Crown Sydney Hotel Resort Modification 3

Amalgamation of apartments
State Significant Development Modification Assessment
(SSD 6957 MOD 3)

July 2020

Figure 6 | Proposed 6 bedroom + study duplex apartment layout on Level 48 (Source: MOD 3)

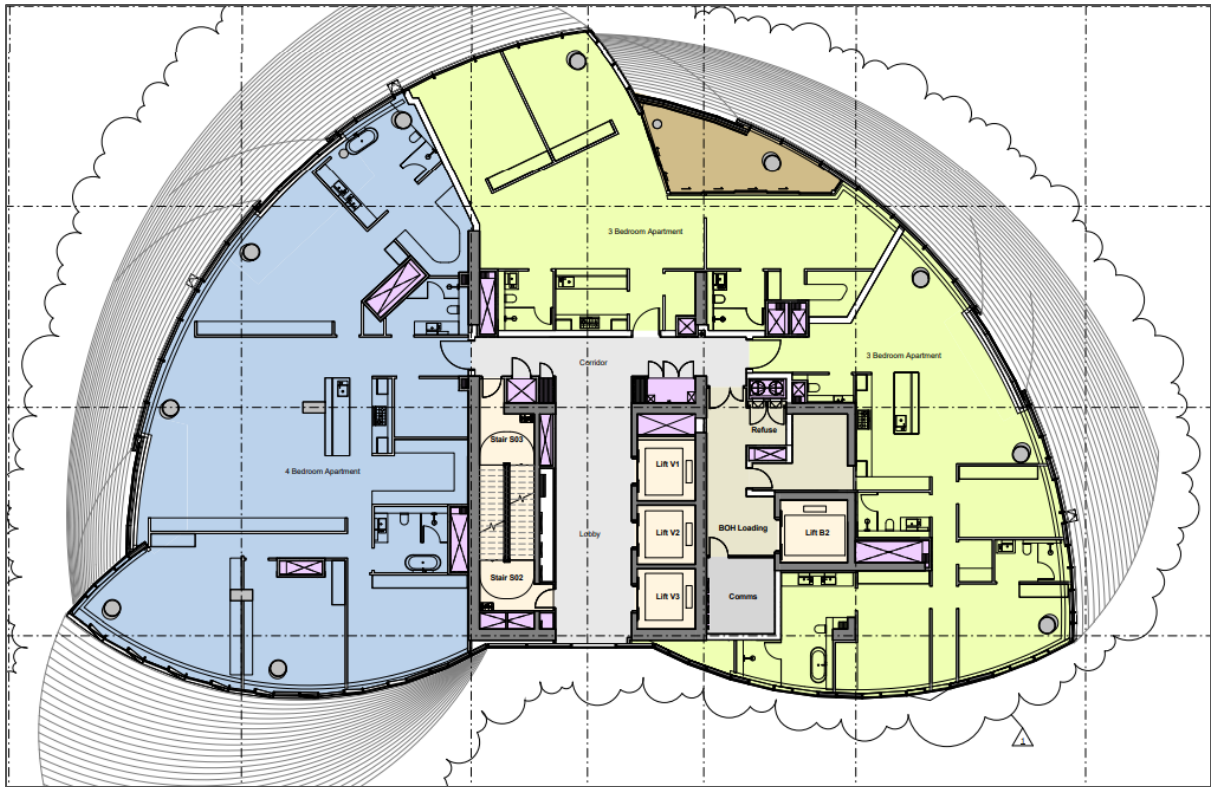
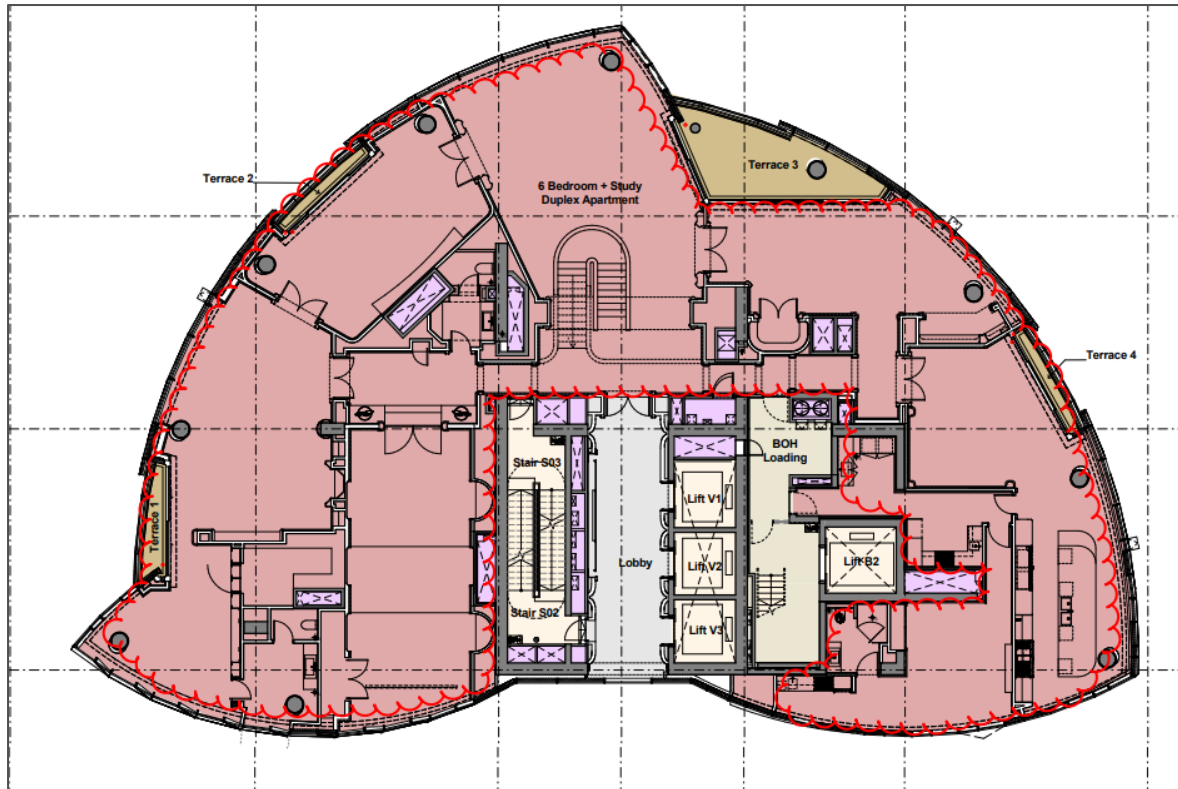
The proposed modification would reduce the total number of residential apartments from 81 to 76 and decrease the total residential GFA by 61 m² from 22,525 m² to 22,464 m². The proposed works seek to remove and rearrange the internal walls of the apartments to create a larger single amalgamated apartment. No changes to car parking are proposed.

The proposal seeks to reduce the total number of approved apartments by five from 81 to 76 by amalgamating six apartments across two levels of the building (levels 48 and 49). The Applicant has advised the amalgamation of apartments into a single duplex apartment is necessary due to a specific buyer request.

The proposal would decrease the number of two-bedroom apartments from 25 to 24, decrease the number of three-bedroom apartments from 36 to 33 and decrease the number of four-bedroom apartments from 19 to 17. The proposal would create a new six bedroom plus study duplex apartment with a floor area of approximately 1,340 m².

The Department considers the revised unit mix is acceptable as the proposed changes are minor and the proposal retains an appropriate range of different unit types and sizes. The new apartment would still provide a high level of amenity for its future residents (considered further in **Section 5.3** and

The Department is therefore satisfied the revised dwelling mix is acceptable and the proposal would not result in any additional impacts beyond those already assessed and approved.
